Bubbled areas indicate revisions  
compared to the previously  
submitted plans

# 780 BLANSHARD - REHABILITATION + ADDITION

HAV00034 CONCURRENT WITH REZ00825

DATE	REV	ISSUE DESCRIPTION
2022-02-24	1	REZONING PRE-APPLICATION
2022-06-01	2	OPEN HOUSE PROGRESS SET
2022-06-21	3	REZONING APPLICATION
2023-03-23	4	HAP & REZONING RESUBMISSION

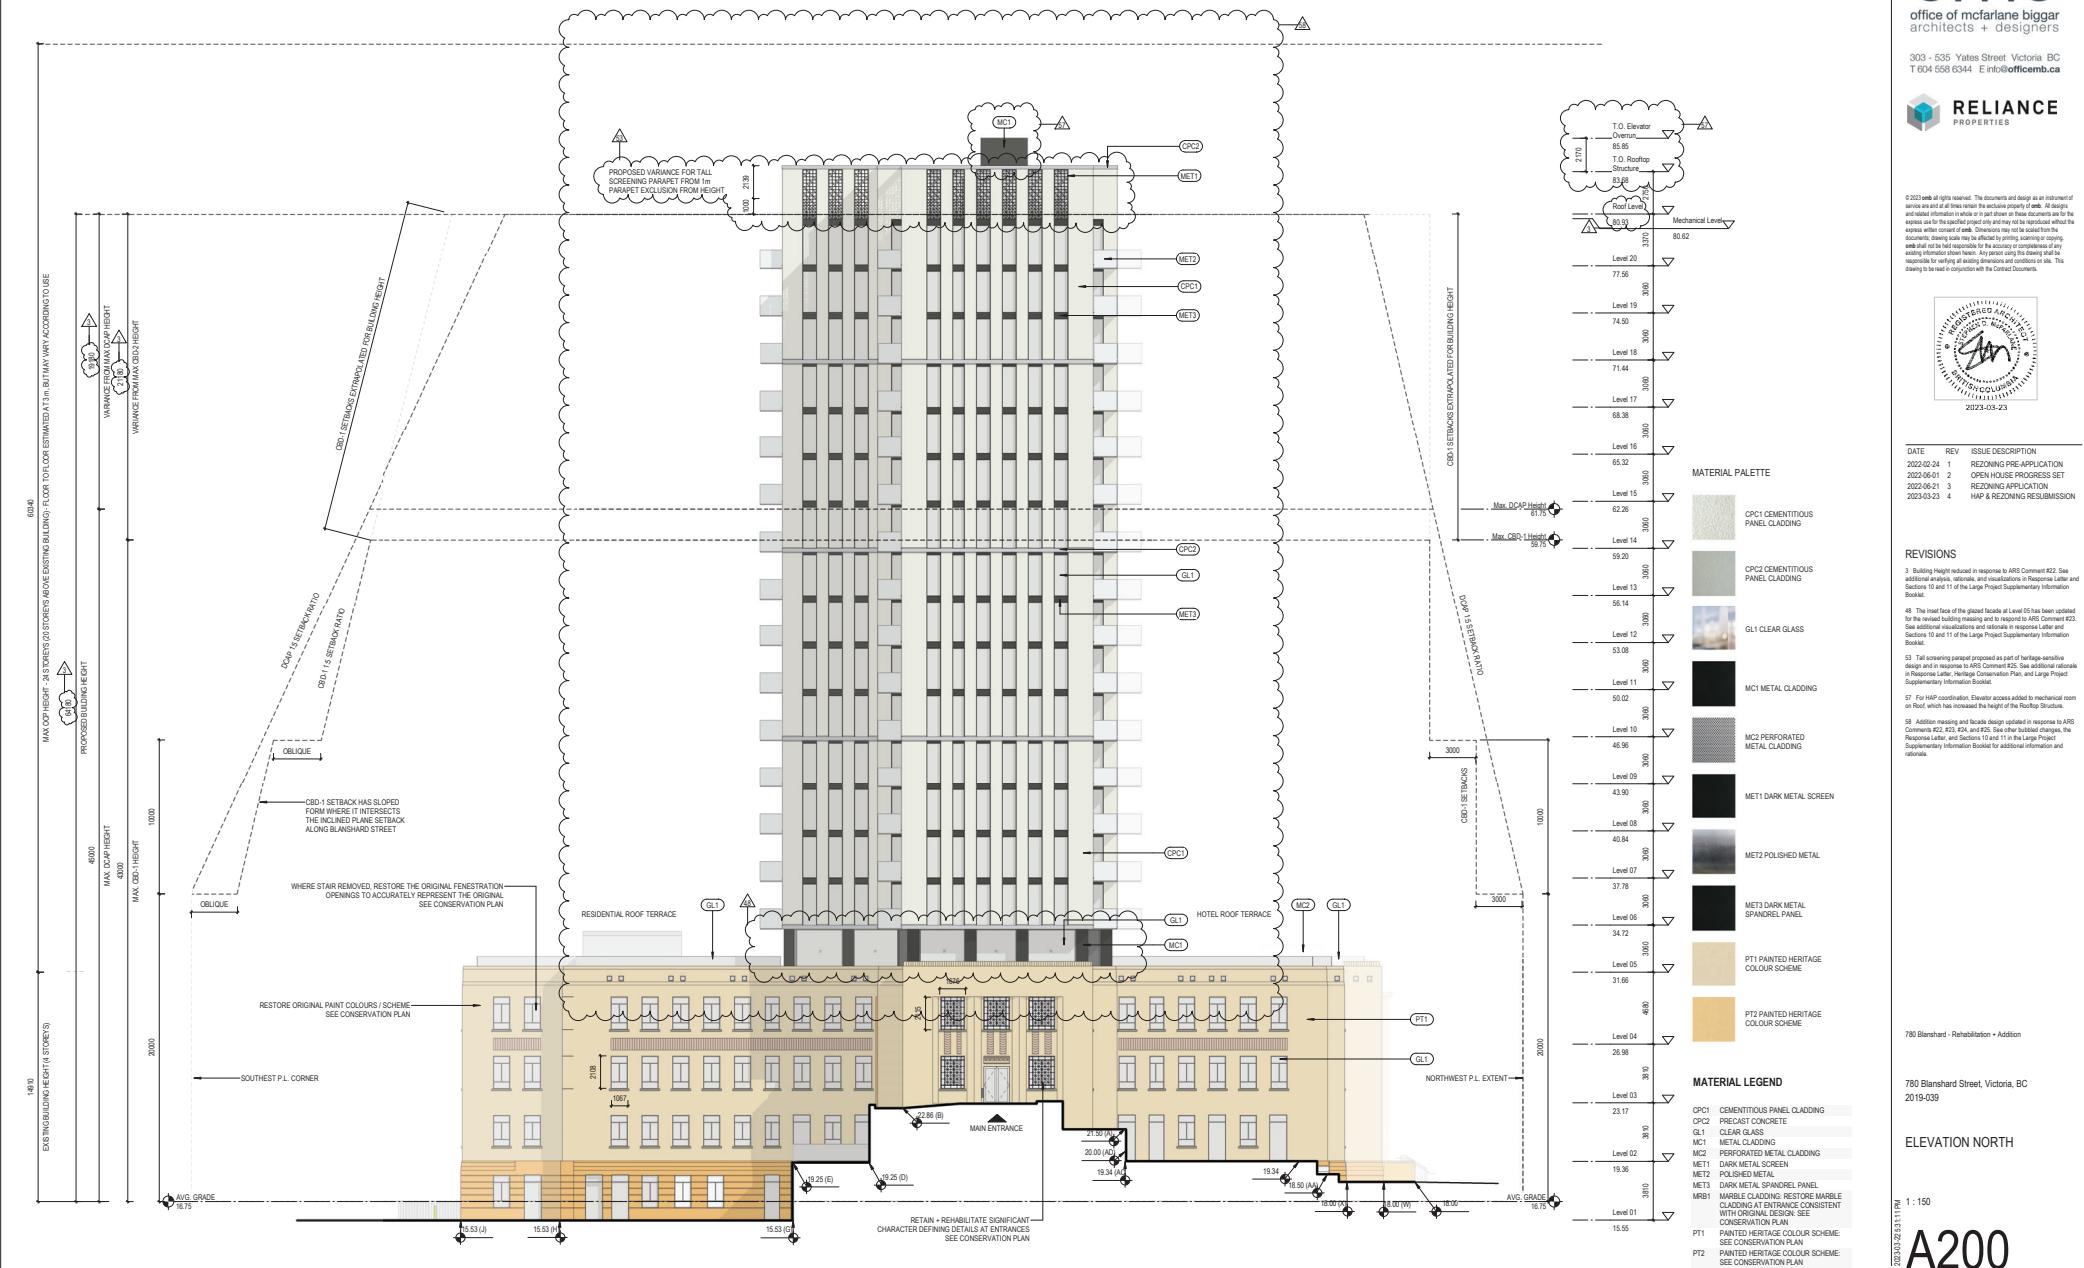
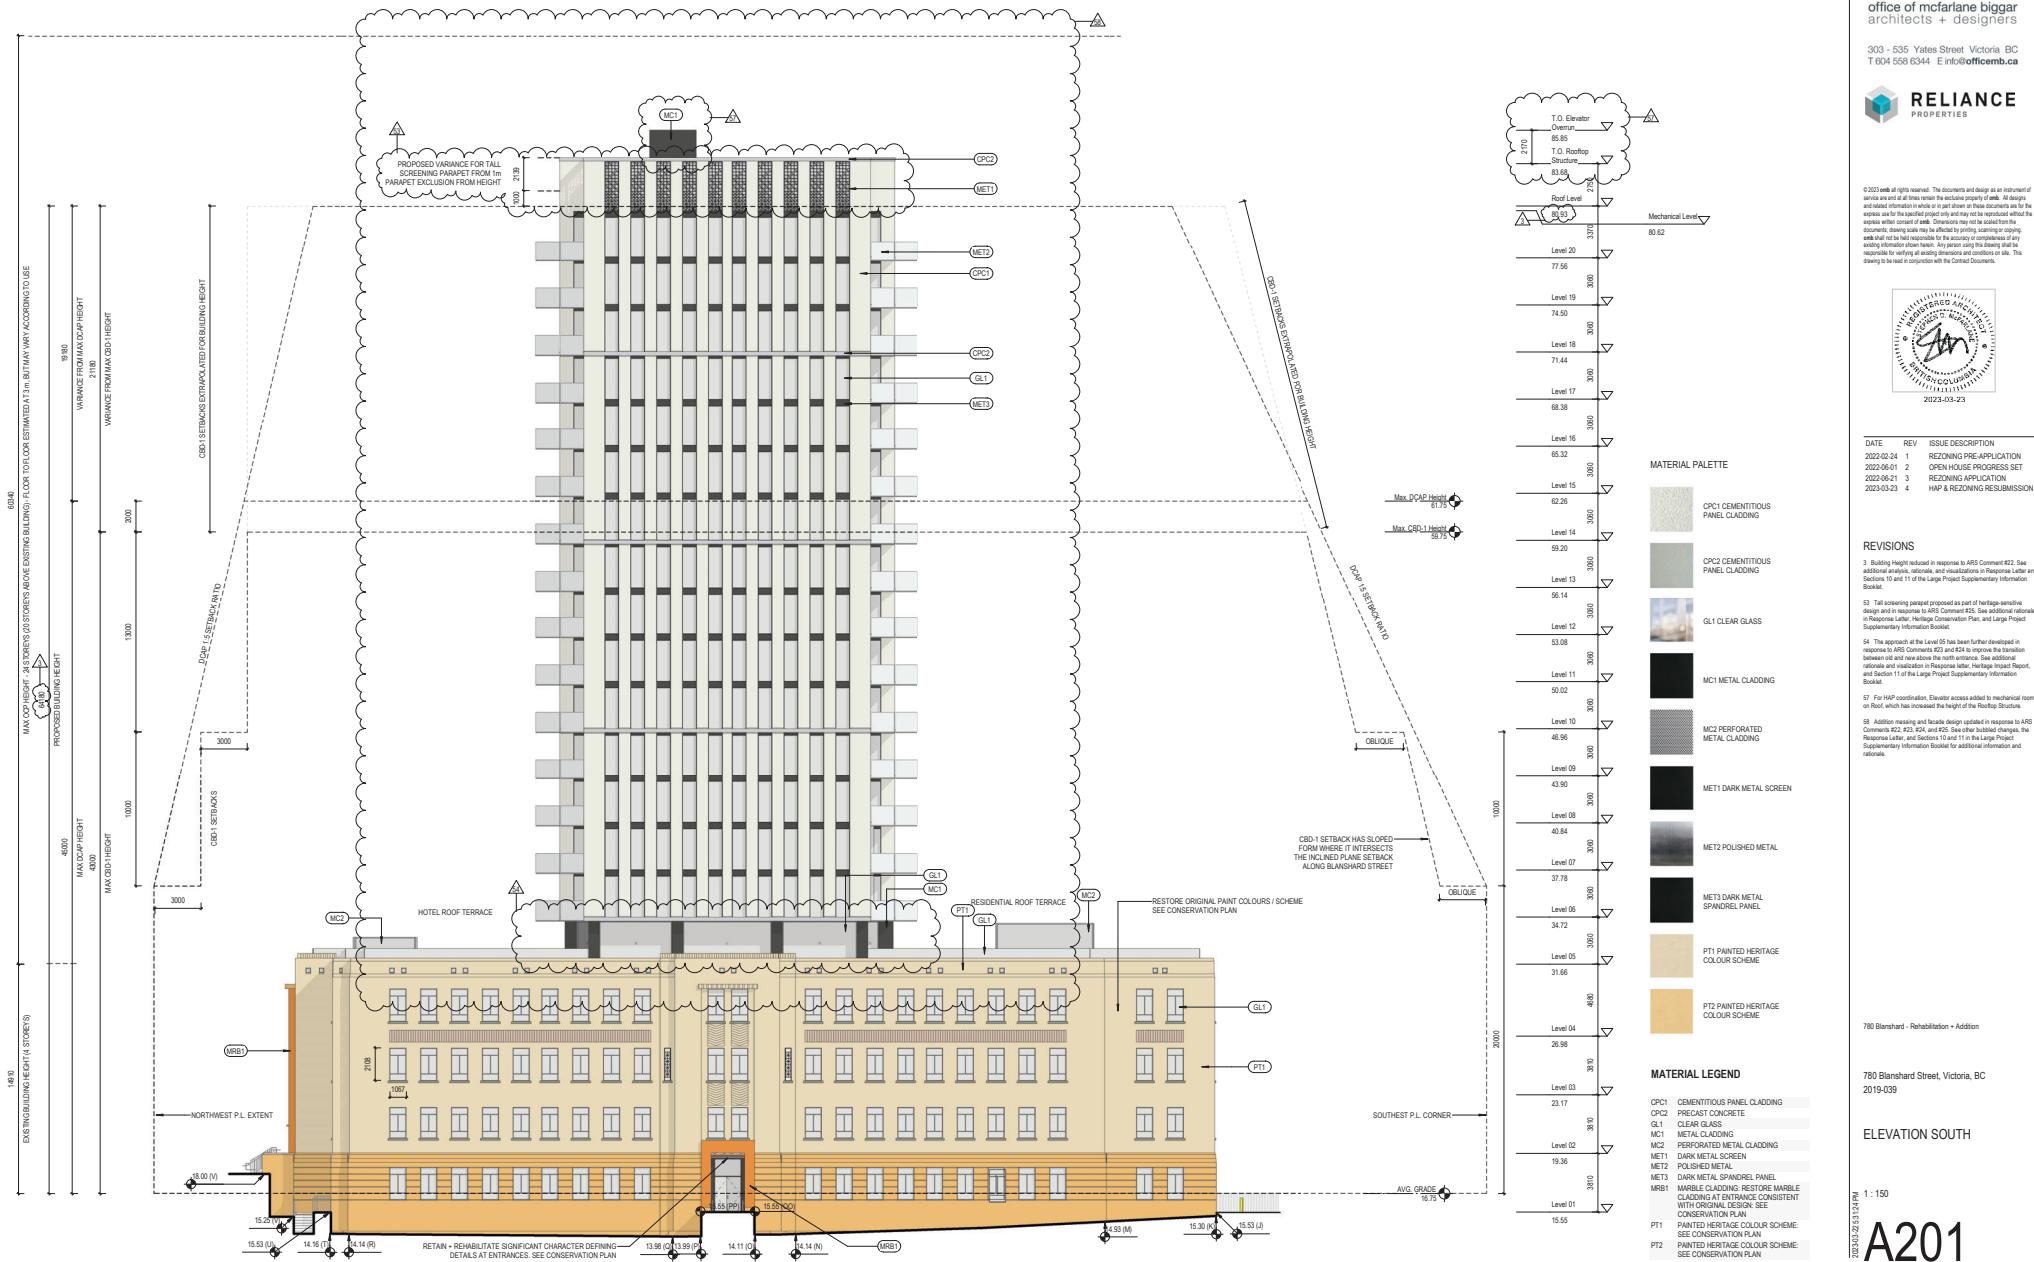
3 Building Height reduced in response to ARS Comment #22. See additional analysis, rationale, and visualizations in Response Letter Sections 10 and 11 of the Large Project Supplementary Information Booklet.

53. Tall screening parapet proposed as part of heritage-sensitive design and in response to ARS Comment #25. See additional rationale in Response Letter, Heritage Conservation Plan, and Large Project Supplementary Information Booklet.

57 For HAP coordination, Elevator access added to mechanical on Roof, which has increased the height of the Rooftop Structure

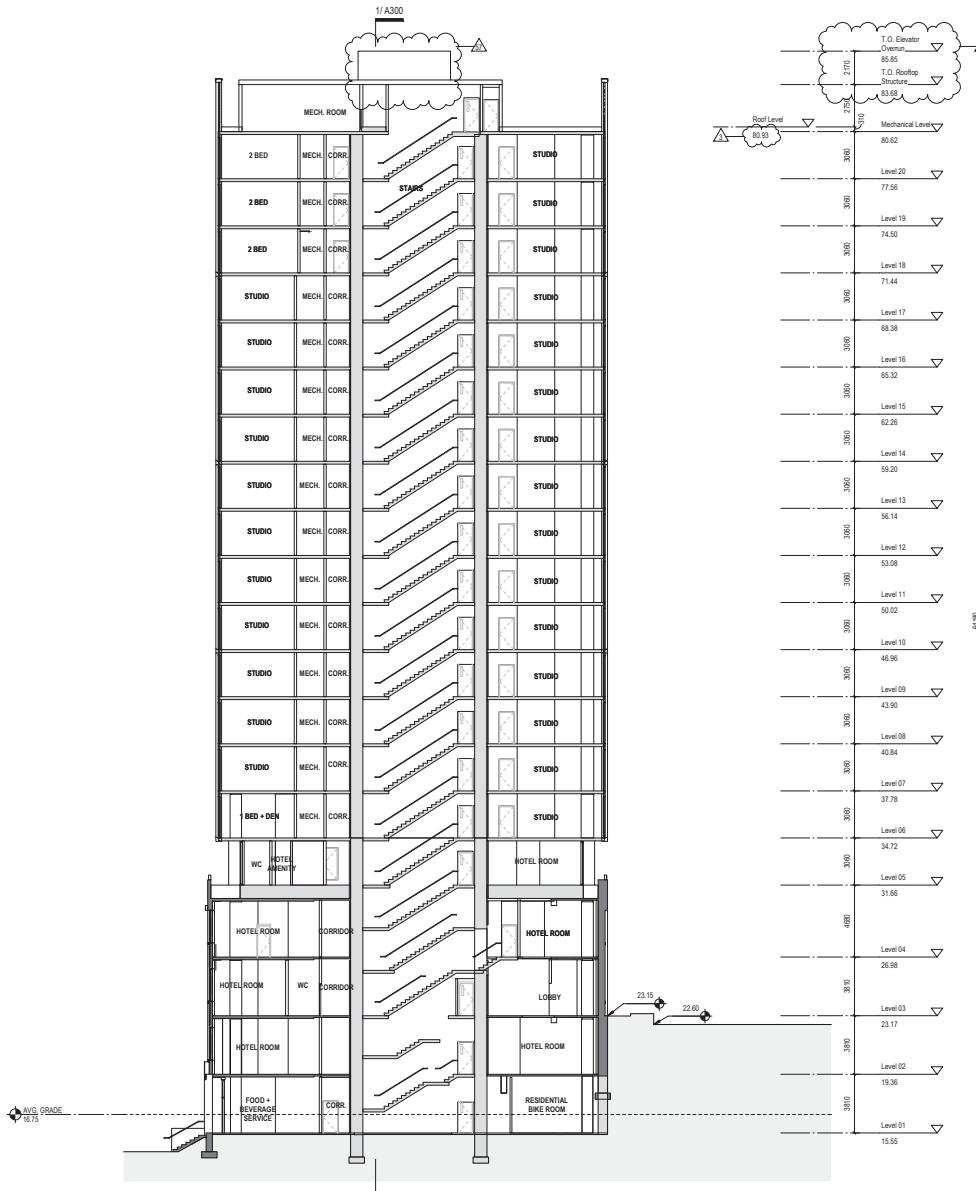
3 Building Height reduced in response to ARS Comment #22. See additional analysis, rationale, and visualizations in Response Letter Sections 10 and 11 of the Large Project Supplementary Information Booklet.

57 For HAP coordination, Elevator access added to mechanical room on Roof, which has increased the height of the Rooftop Structure.
